CLIVE PLANNING & ZONING COMMISSION

RE: Site Plan Amendment - Tenant and Facade Updates - 10001 University Ave

Re: 10001 UNIVERSITY AVE - drive through and parking addition - Site Plan Amendment

SITE PLAN FOR:
10001 UNIVERSITY
CLIVE, IOWA

LANDSCAPE PLAN

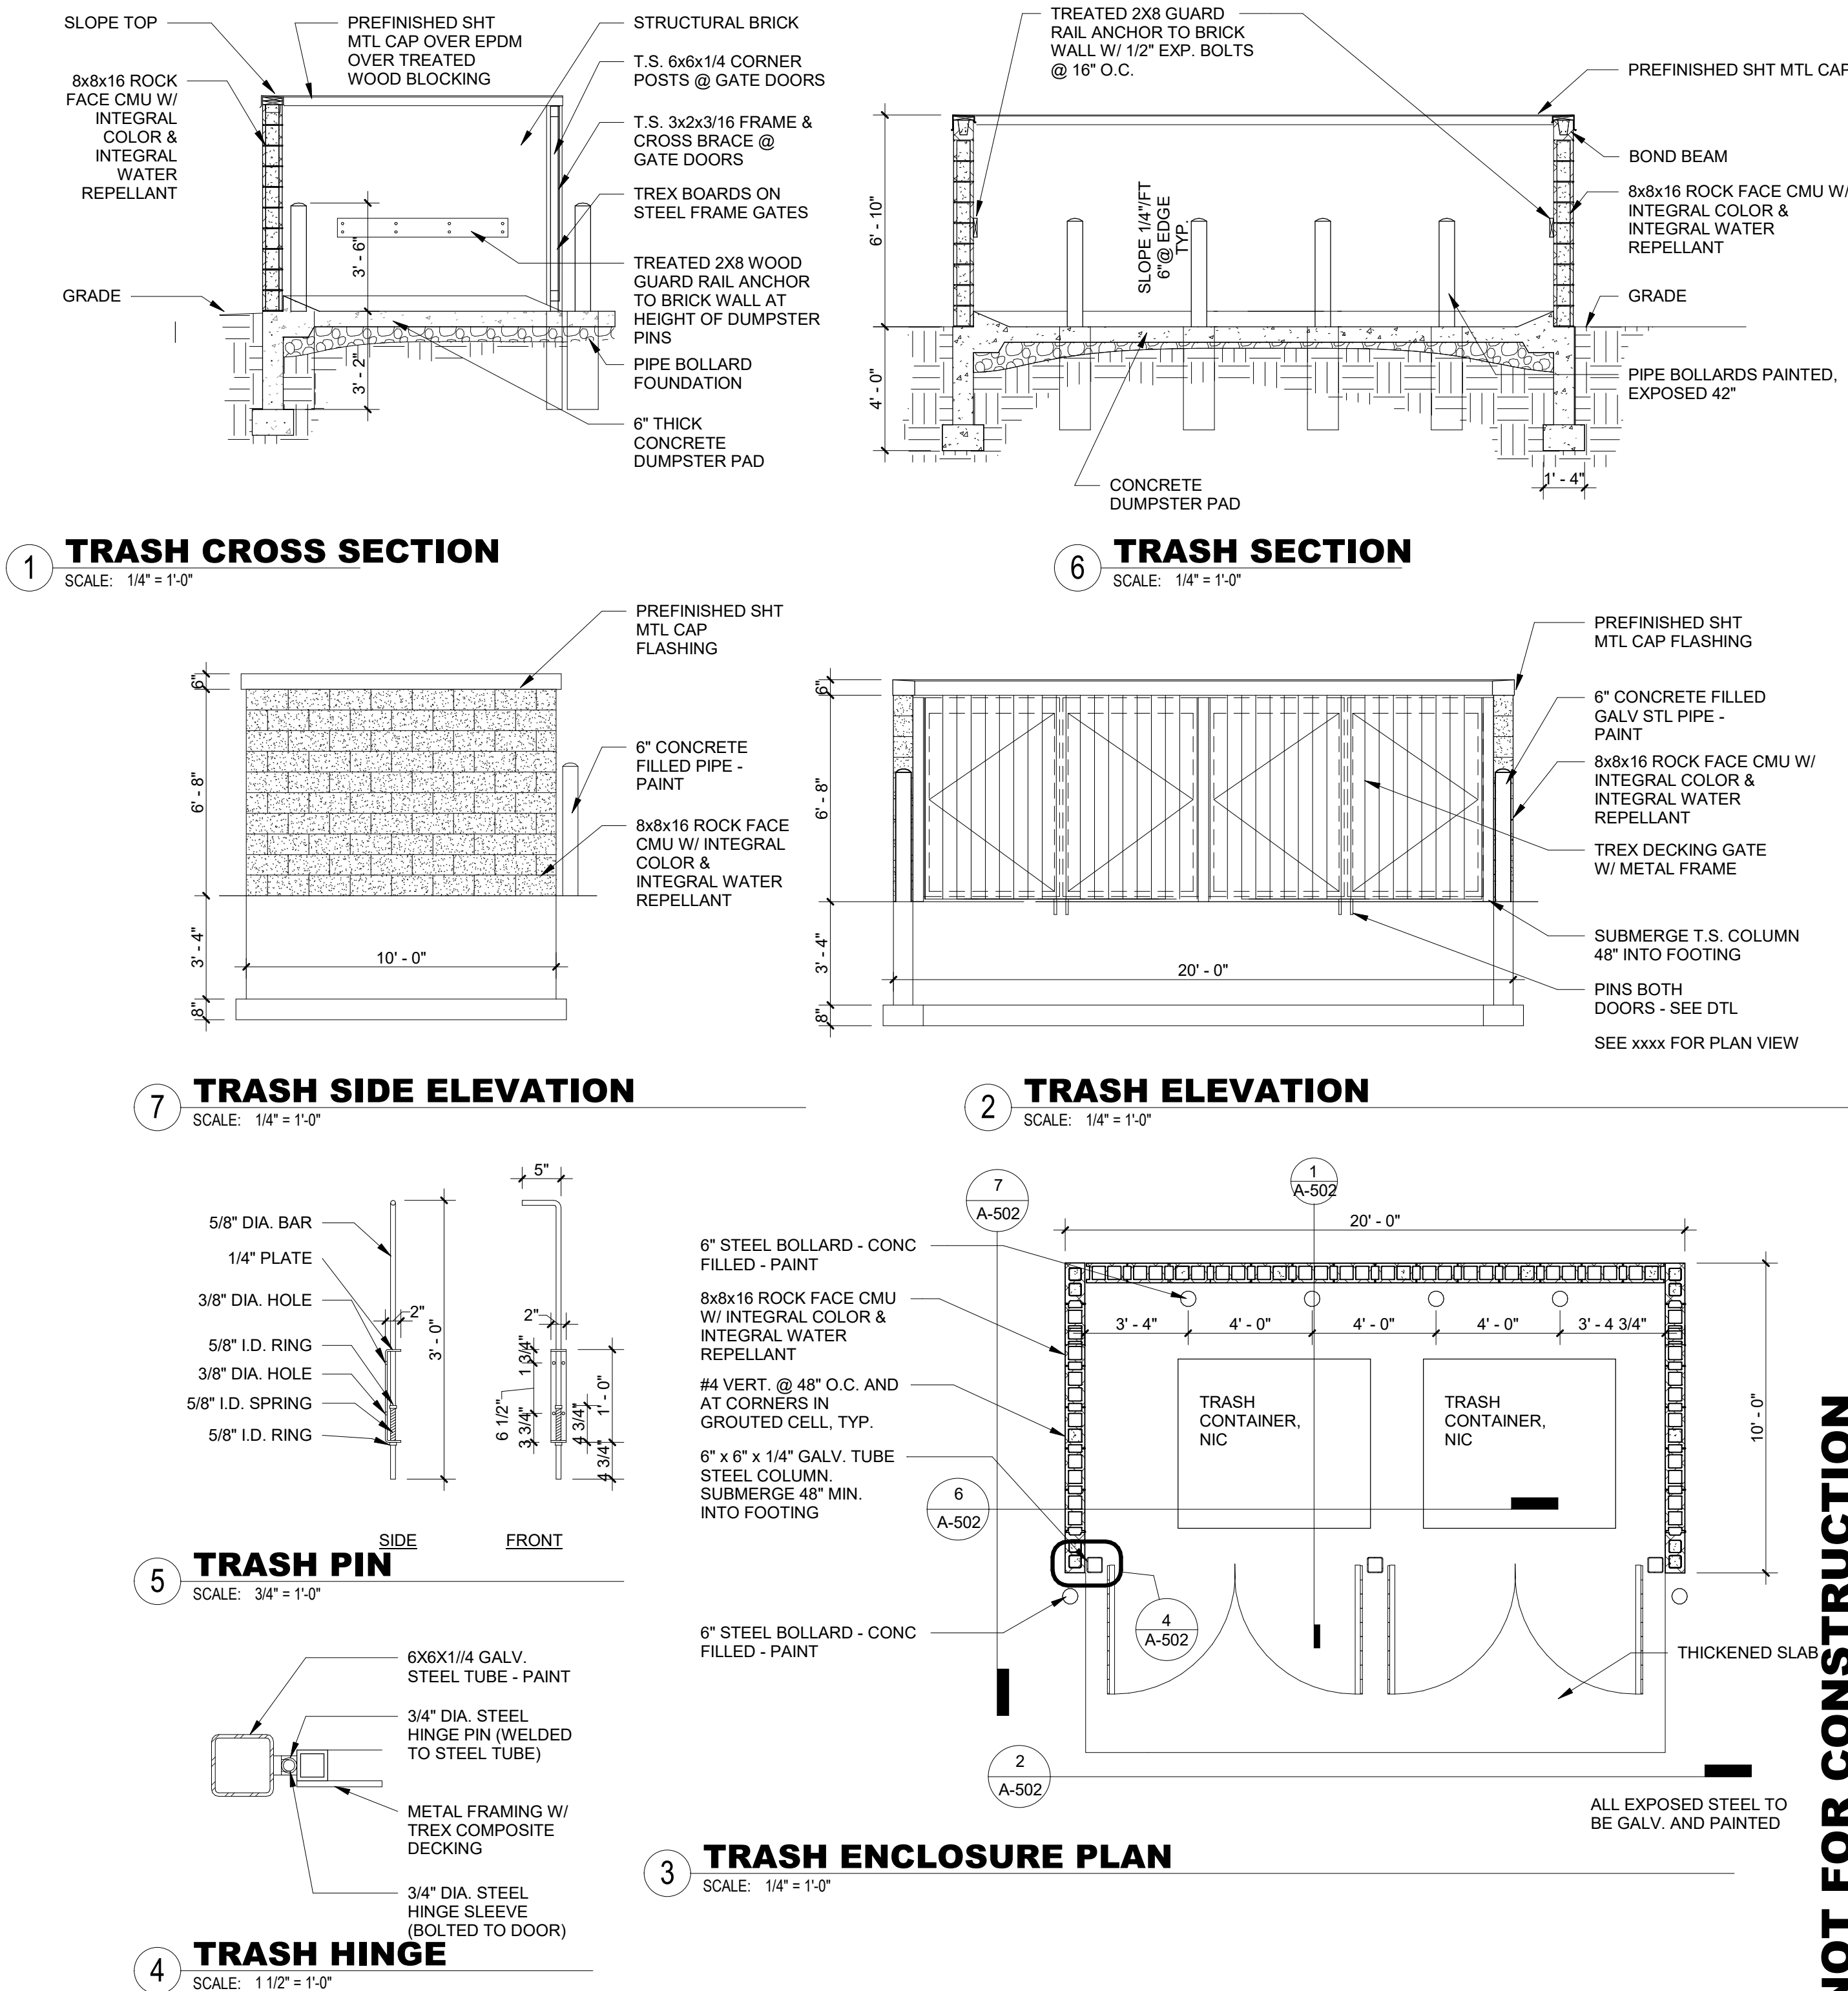
1. Approximately 35" of tree caliper is being removed and 11.5" of tree caliper is being replanted, leaving 23.5" of caliper left to be addressed. Provide a cost estimate for 23.5" of trees so staff can verify the amount to be paid to the City for replacements elsewhere.

1. Update the landscape plan to include plantings in the drive thru island. Tree plantings are not required in this location.
2. Approximately 35" of tree caliper is being removed. Identify replacement tree plantings on-site, as space allows. Remaining tree caliper that cannot feasibly be replaced on-site may be paid to the City for replacements elsewhere.
3. Update landscape note #5 to only include sod.
4. At the time of initial development, the site had 16 trees. Update the landscaping plan to identify at least 16 trees between existing and proposed plantings.
